TENNESSEE VALLEY AUTHORITY

Enclosed for NRC review is information concerning sheet pile walls at Watts Bar Nuclear Plant. This information should resolve open item 7 of the draft Safety Evaluation Report.

WATTS BAR NUCLEAR PLANT UNITS 1 AND 2  
SHEET PILE WALLS

Figure 2: Figures used in procedure to estimate bending moment in sheetpile wall (Reference Figure 1)

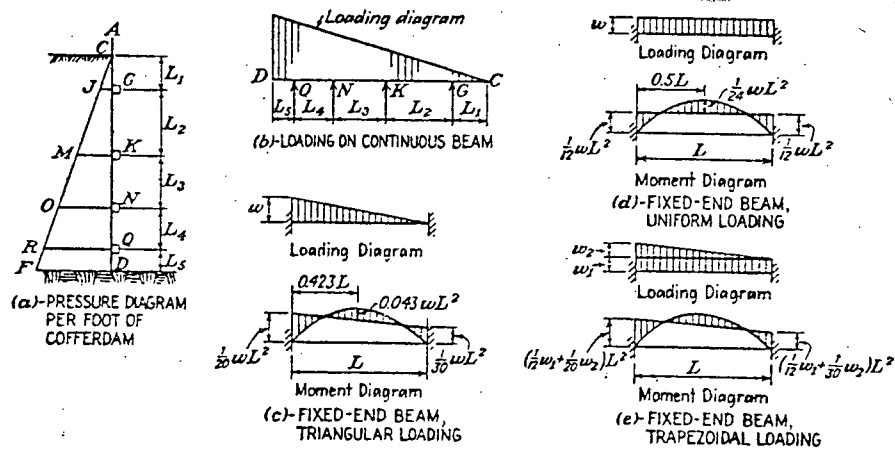
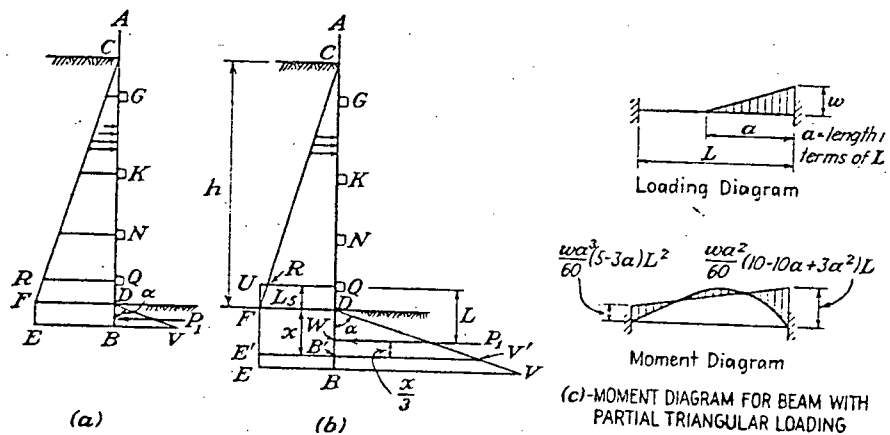
A description of the method of static and dynamic analysis of the tieback sheetpile walls, and the results of the analysis should be promptly provided by the applicant for staff review. The applicant should include in the FSAR a list of soil-related parameters, including anchorage used in the design, the design values of these parameters, and the bases for obtaining the design values used in the analysis.

The static loads of the required load cases were calculated following the method presented in Chapter 11 of Foundation of Structures by C. W. Dunham, McGraw-Hill, 1962. The applicable portion of this text is presented in figures 1 and 2. A value of 210 psf per foot of depth was used for the unit passive pressure ( $P_n$ ) and 32 psf per foot of depth was used for the unit active pressure ( $P_a$ ) in the calculations.

When the embedment of  $DB$  is considerable, it can support the shear at the bottom of the piling, and perhaps fix that end against rotation. In this case, the bending moment at  $Q$  and in the portion  $QB$  may be estimated in the following manner, referring to Fig. 11-13(b):

1. Assume the active-pressure diagram to be the rectangle  $QUEB$ .
2. Assume the passive-pressure diagram to be the triangle  $DVB$ , where angle  $\alpha$  represents  $p_n$  p.s.f. per ft.
3. Assume that the passive pressure will be developed as rapidly as possible to support the piling. Excessive length of  $DB$  over that required will be assumed to fix the piling in position but not to add materially to the reaction or the bending moments.
4. Find the distance  $x$  such that the minimum passive resistance  $DV'B'$  will support one-half of the pressure caused by the diagram  $QUE'B'$ . Thus

5. The resultant passive pressure  $P_1$  will act at  $x/3$  above  $B'$ . Assume this line of action to be the support point for the piling, thus determining the span  $L = QW$ .

6. Assume the span  $QW$  to be fixed at both ends, and compute the fixed-end moment at  $Q$  as  $\frac{1}{12} p_a h L^2 - (p_n DW/60) a^3 (5 - 3a) L^2$ , where the latter term is explained by reference to Fig. 11-13(c).
